Agenda  
Village of Arlington Heights  
Design Commission  
Virtual Meeting

April 13, 2021  
6:30 PM

- A. DC#21-019 - 735 N. Dunton Ave. - SF/New
- B. DC#21-022(H) - 216 N. Haddow Ave. - SF/Teardown
- C. DC#21-023 - Timber Ridge School - 201 S. Evanston Ave. / School

**NSSEO**  
TIMBER RIDGE SCHOOL GYMNASIUM ADDITION

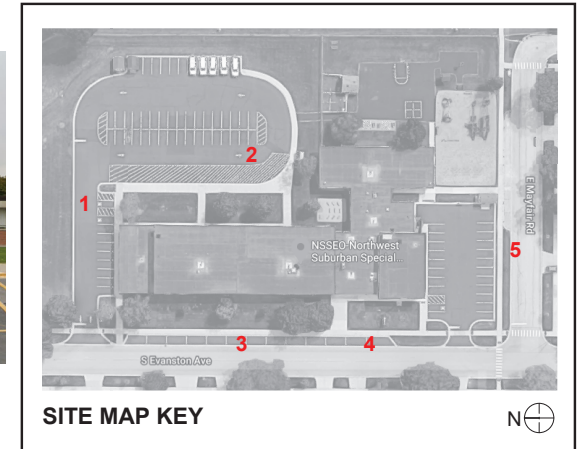
The precast concrete gymnasium will be a prominent feature of the new addition since it will be highly visible from Kensington Road. The blue accent stripe is a nice idea to emphasize the school's theme color. However, the blue stripe is quite large and bold and it intersects the single-story brick portion on the west elevation in an awkward way that obstructs the view of the stripe at the front (west elevation) of the building. Additionally, the remaining "tan" portion of the precast walls are lacking detail.

Further design development of the precast concrete gymnasium exterior is recommended. Additional horizontal reveals are recommended to be added to break up the large tan walls and create a panelized look. Additionally, alternative layouts for the blue accent stripe should be studied. Consider a smaller accent stripe or stripes. For additional interest and refinement, consider

1. Further design development of the precast concrete gymnasium exterior is recommended. Additional horizontal reveals are recommended to be added to break up the large tan walls and create a panelized look. Additionally, alternative layouts for the blue accent stripe should be studied. Consider a smaller accent stripe or stripes.
